SEISMIC RISK BUILDINGS - SURVEY

DURHAM ST METHODIST CHURCH  
309 DURHAM ST.

# DURHAM ST METHODIST CHURCH

Thank you for forwarding to us the proposed temporary propping details for Durham Street Methodist church (SP 01A, S.01A, S.02, S.03, D.01, D.03 and one unlabelled sheet), designed by RD Sullivan, consulting engineer.

DETAIL A.

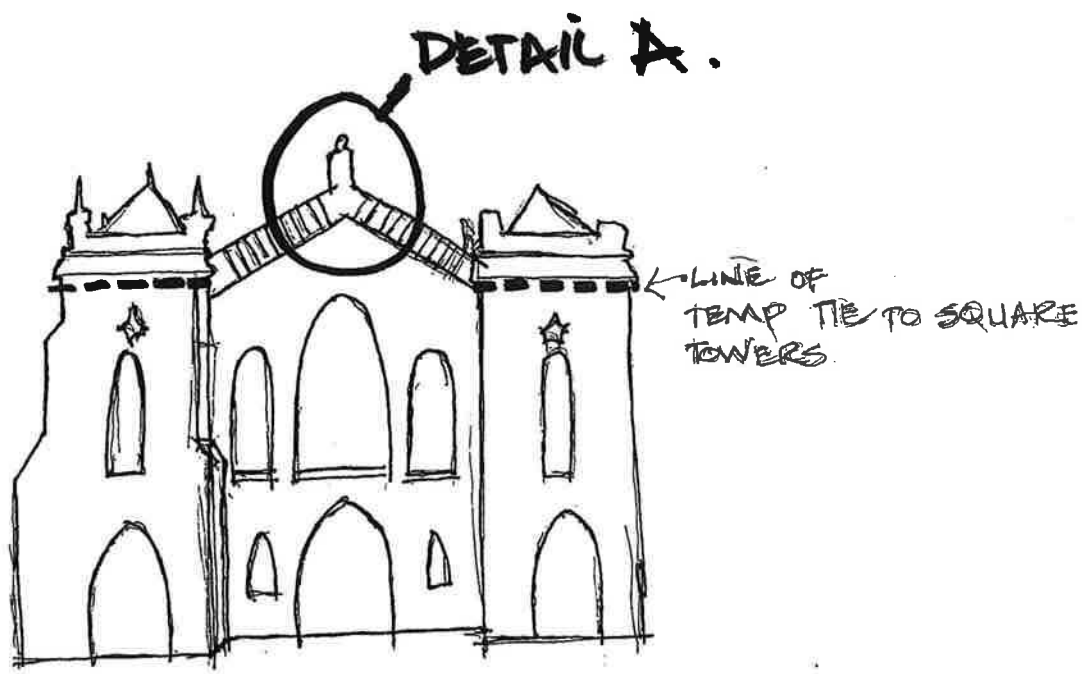
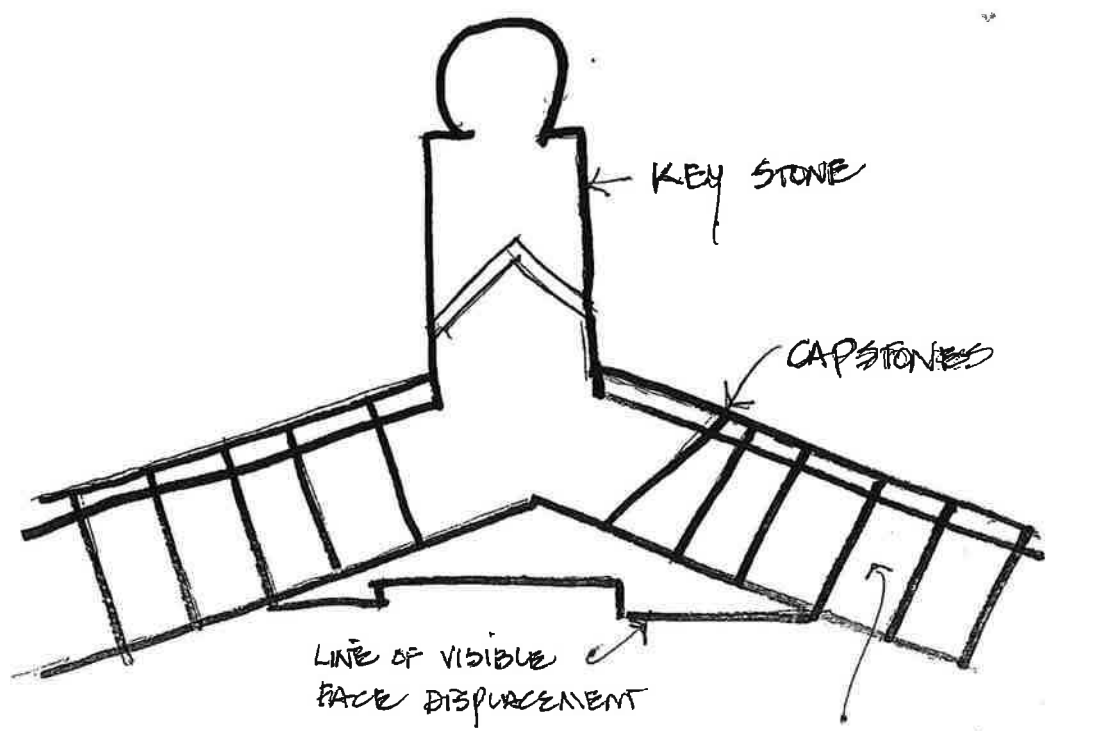
1 The intention is to remove the gable key stone along with several visibly loose/ displaced face blocks, cap stones and decorative parapet blocks.

See attached sketch Detail A

3 We will avoid any situation which will result in workmen needing to be on the roof.

4 We will be careful to ensure the removal operation does not induce any additional lateral load on the gable.
